Access Compliance Report Public Rights-of-Way (Curb Ramps)

Main Street: MONTECITO_RD		Cross Street: KEMPTON_DR		Location:	SW
ADA ID: RPRK211208122802	Ramp Type: Type 4 - Parallel	Initial Pass/Fail: Fail	Overall Compliance: No	Severity Score:	15

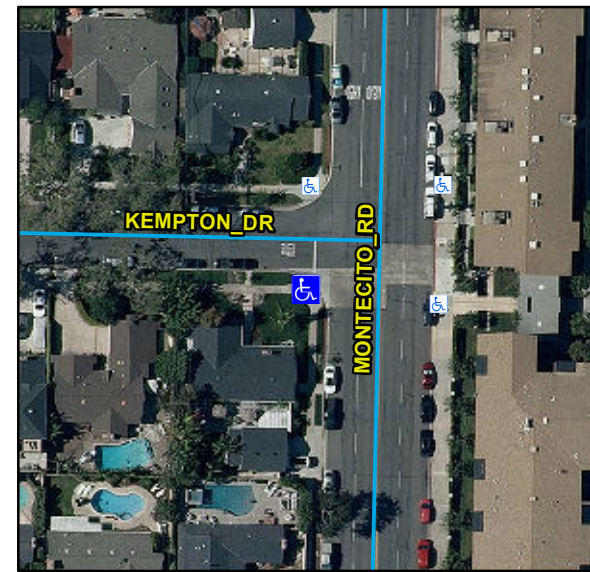
Compliance	Description	Data	Compliance	Description	Data
N/A	Ramp Length LT (in)	97	N/A	Ramp Length RT (in)	80
Yes	Ramp Width LT (in)	108	Yes	Ramp Width RT (in)	108
Yes	Ramp Run Slope LT (%)	4.5	Yes	Ramp Run Slope RT (%)	6.8
No	Ramp Cross Slope LT (%)	4.4	No	Ramp Cross Slope RT (%)	6.2
N/A	Landing Present	N/A	N/A	DWS Provided	N/A
N/A	Landing Length (in)	N/A	N/A	DWS Contrast	N/A
N/A	Landing Width (in)	N/A	N/A	DWS Length (in)	N/A
N/A	Landing Run Slope (%)	N/A	N/A	DWS Full Width	N/A
N/A	Landing Cross Slope (%)	N/A		DWS Offset Type	N/A
N/A	Landing Movement Obstructed?	N/A	N/A	DWS Offset Left (in)	N/A
	Landing Movement Type	N/A	N/A	DWS Offset Right (in)	N/A
N/A	Landing Shared	N/A			
N/A	Clear Space	Yes			
N/A	Clear Space To Crosswalk (in)	N/A			
N/A	Marked Crosswalk 1	No	N/A	Marked Crosswalk 2	No
	Crossing 1 Direction	E		Crossing 2 Direction	N
	Marked Crosswalk 1 Width (in)	N/A		Marked Crosswalk 2 Width (in)	N/A

Remove & Replace Curb Ramp With Two New Directional Ramps or Equivalent.
